23 April 2018
Our Ref: 8301G.1 S4.55(1A)

**RE: SECTION 4.55(1A) APPLICATION TO MODIFY
DEVELOPMENT CONSENT NO. 267/13 (as modified)
6-14 MACPHERSON STREET, WARRIEWOOD**

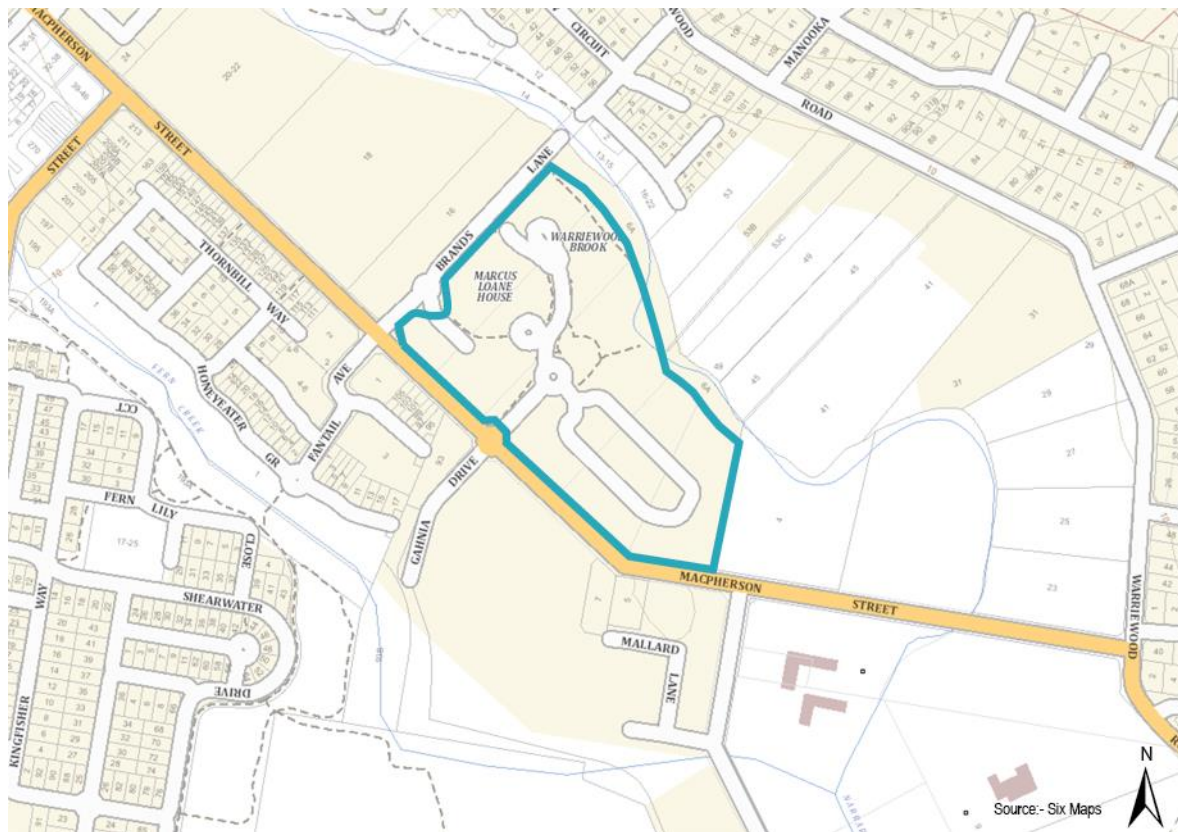
Section 4.0 of this submission outlines the proposed modifications to the consent in respect to the amended Landscape Site Plan prepared by Wallman Partners Pty Ltd being Drawing

18:4:2/LA1'B' dated 20 April 2018 annotated over the original Landscape Site Plan Drawing No. LP-1.0 Revision 14 dated 16 February 2016 prepared by John Lock and Associates (see **Appendix 2**). The amended Landscape Site Plan shows the location for the proposed removal and replacement of 32 trees at Glasshouse Circuit and the main walkway within the site.

The existing trees to be removed are all *Corymbia gummifera* (Red Bloodwood) tree species which are considered to be inappropriate for their locations. The existing trees are to be replaced with 32 *Tristaniopsis laurina* "Luscious" (Water Gum) tree species which are a smaller, less invasive native tree species to be introduced to the streetscape.

- *Landscape Site Plan LP-1.0 Revision 14 dated 16/02/16 prepared by John Lock and Associates and Plan annotated Drawing No. 18:4:2/LA1 ‘B’ dated 20/04/18 prepared by Wallman Partners Pty Ltd relating to the removal and replacement of 32 trees.”*

*It is recommended that a smaller, less invasive tree species be introduced to the streetscape. Selected species **Tristanopsis laurina** “**Luscious**” (Water Gum). 75 litre size container. This species has the advantage of being easily trimmed to provide clear sight-lines under its canopy, while still retaining its natural uniform (elongated spheroid) shape. The approximate upper-end mature size of 8m tall x 4m spread will fit a lot more appropriately into the spaces at Glasshouse Circuit. This species is readily available at Sydney metropolitan nurseries.”*
